FROM: Duke Power Company Charlotte, N. C. 28201 A. C. Thies			DATE OF DOC 12-31-73	DATE REC'D 1-9-74	LTR X	MEMO	RPT	OTHER
TO: A. Giambusso			ORIG 3 signed	CC	OTHER	SENT AEC PDR		X
						SENT LOCAL PDR		X
CLASS	UNCLASS XXXX	PROP INFO 1	INPUT X	NO CYS REC'D 40	DOCKET NO: <u>50-269/270</u>

ENCLOSURES:
Request for change to TECH SPEC for Oconee Units 1 & 2

Re: Oconee Nuclear Station
Units 1 and 2
Docket Nos. 50-269 and -270

Please find attached replacement pages for Oconee Technical Specification 3.5.2. It is requested that these changes, as indicated by vertical lines in the margins of the replacement pages, and the attached figures be approved and incorporated in the Oconee Technical Specifications.

CONTROL ROD GROUP WITHDRAWAL
LIMITS FOR 3 AND 2 PUMP OPERATION

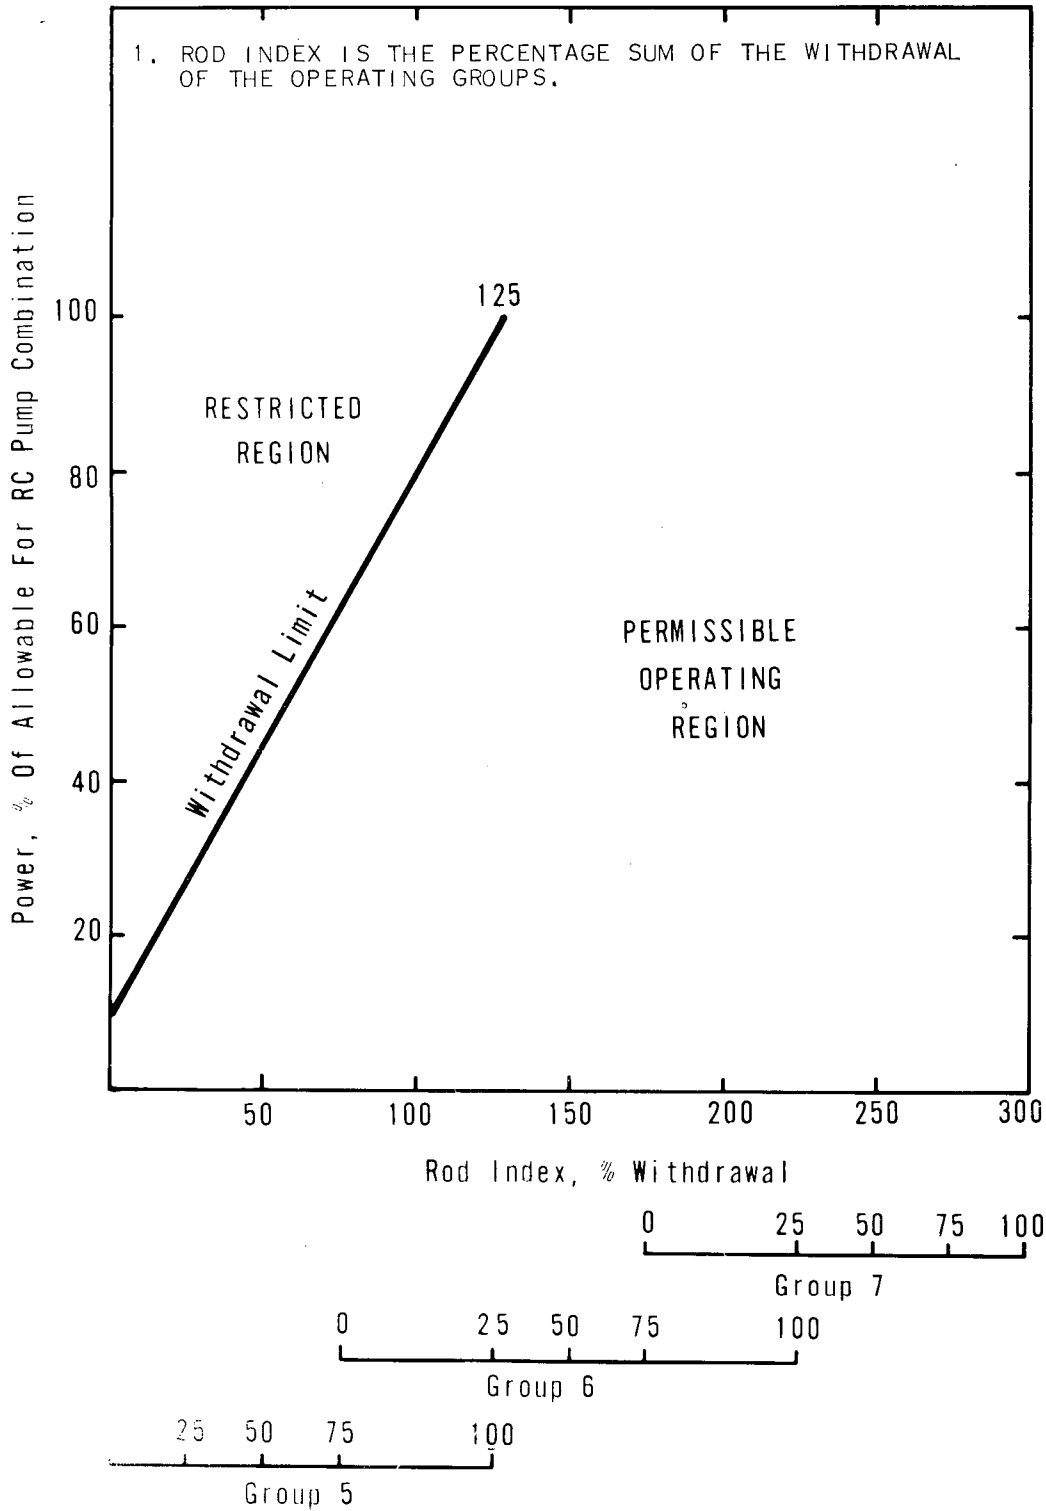
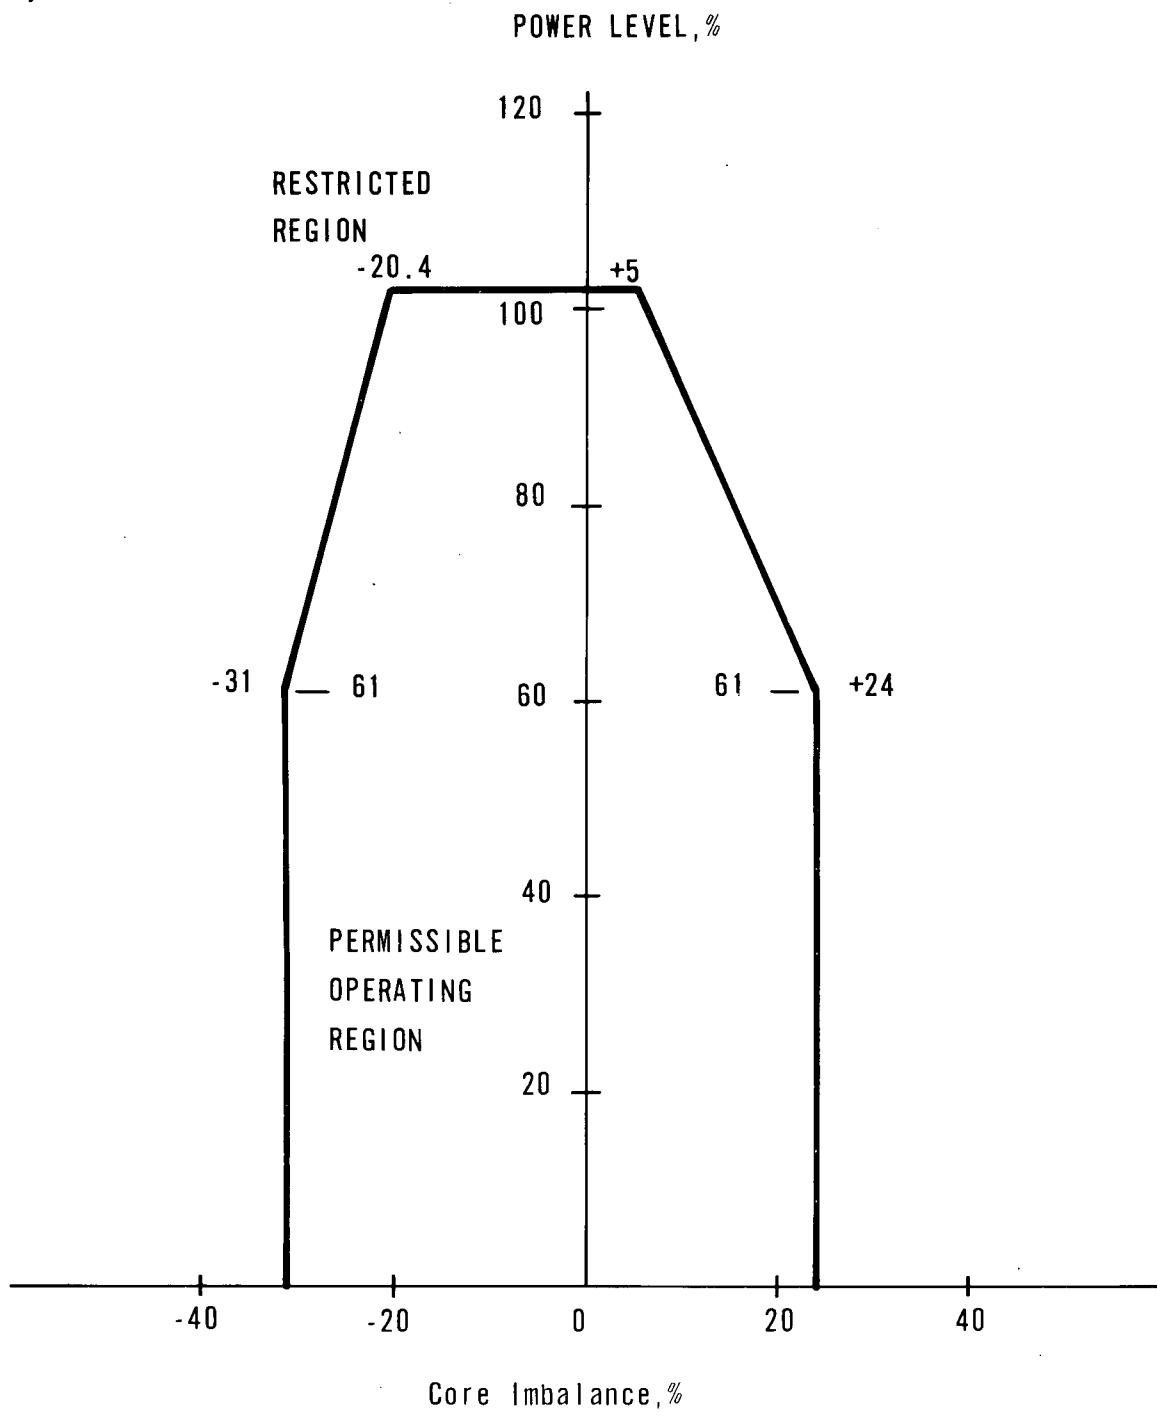
- c. Except for physics tests or exercising control rods, the control rod withdrawal limits are specified on Figures 3.5.2-1A1, 3.5.2-1B1, 3.5.2-1A2, and 3.5.2-1B2 for four pump operation and on Figure 3.5.2-2A and 3.5.2-2B for three or two pump operation. If the control rod position limits are exceeded, corrective measures shall be taken immediately to achieve an acceptable control rod position. Acceptable control rod positions shall be attained within four hours.
- d. Except for physics tests, power shall not be increased above the power level cutoff (see Figures 3.5.2-1) unless the xenon reactivity is within 10% of the equilibrium value for operation at rated power and asymptotically approaching stability.

UNIT 1
 OCONEE NUCLEAR STATION
 Figure 3.5.2-3A

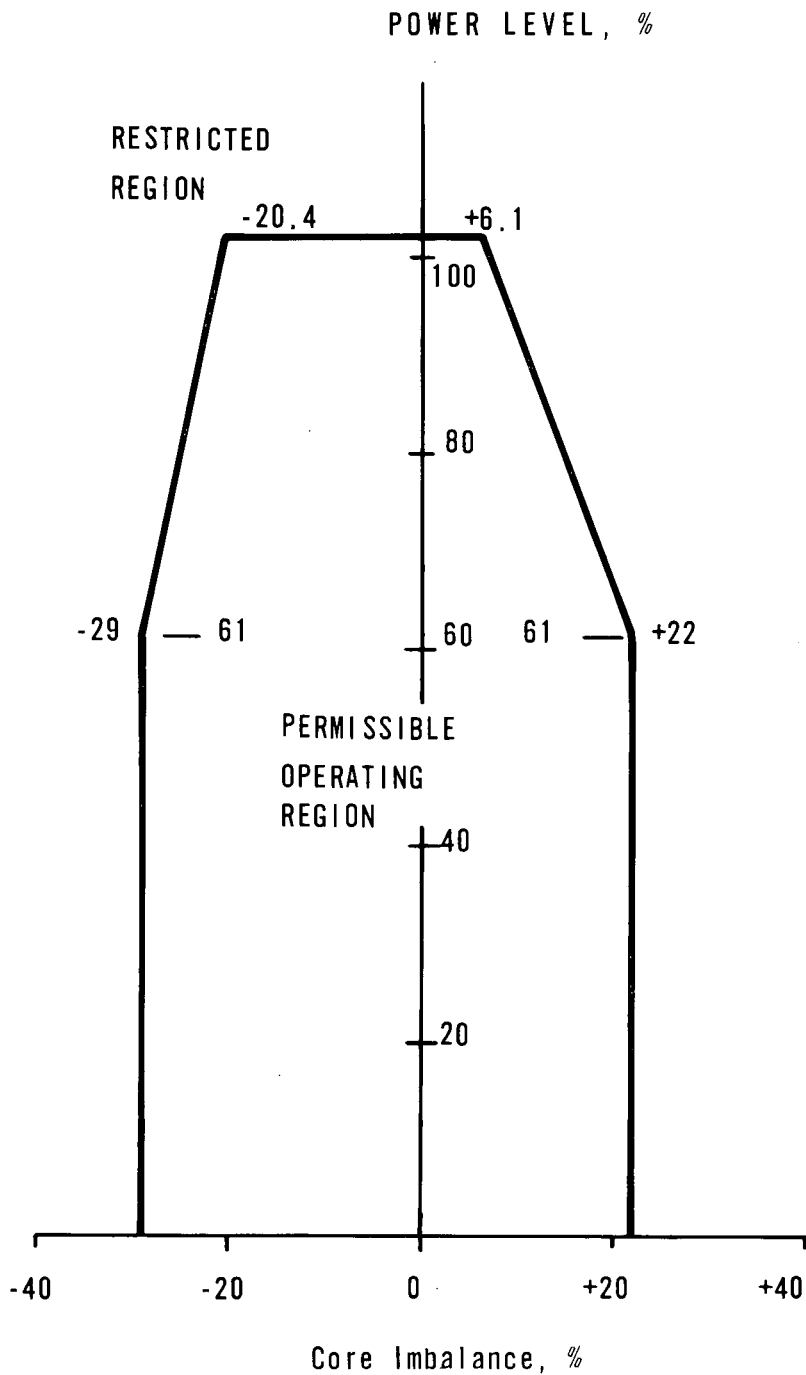
- 3. The operational imbalance limits (Figure 3.5.2-3A-Unit 1; 3.5.2-3B-Unit 2) shall be reduced 2% in power for each 1% tilt in excess of 4%.
- c. If quadrant tilt is in excess of 25%, except for physics tests or diagnostic testing, the reactor will be placed in the hot shutdown condition. Diagnostic testing during power operation with a quadrant power tilt is permitted provided the thermal power allowable for the reactor coolant pump combination is restricted as stated in 3.5.2.4.a above.

3.5.2.6 Reactor Power Imbalance shall be monitored on a frequency not to exceed two hours during power operation above 40 percent rated power. Except for physics tests, imbalance shall be maintained within the envelope defined by Figure 3.5.2-3A and 3.5.2-3B. If the imbalance is not within the envelope defined by Figure 3.5.2-3A and 3.5.2-3B, corrective measures shall be taken to achieve an acceptable imbalance. If an acceptable imbalance is not achieved within four hours, reactor power shall be reduced until imbalance limits are met.

LOCA LIMITED MAXIMUM ALLOWABLE
LINEAR HEAT RATE

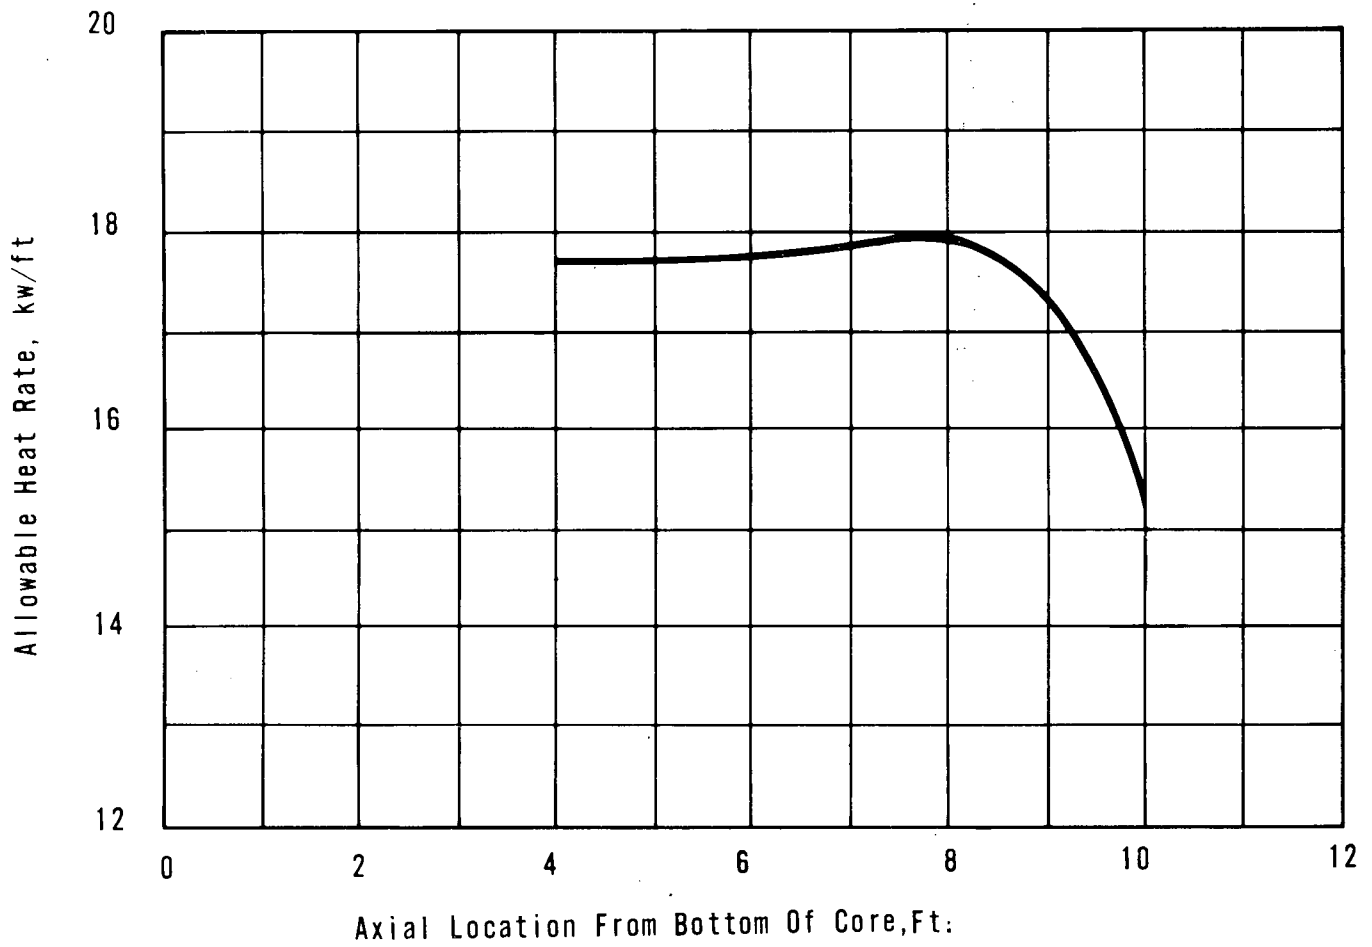
The power-imbalance envelope defined in Figure 3.5.2-3A and 3.5.2-3B is based on LOCA analyses which have defined the maximum linear heat rate (see Figure 3.5.2-4) such that the maximum clad temperature will not exceed the Interim Acceptance Criteria. Corrective measures will be taken immediately should the indicated quadrant tilt, rod position, or imbalance be outside their specified boundary. Operation in a situation that would cause the interim acceptance criteria to be approached should a LOCA occur is highly improbable because all of the power distribution parameters (quadrant tilt, rod position, and imbalance) must be at their limits while simultaneously all other engineering and uncertainty factors are also at their limits.* Conservatism is introduced by application of:
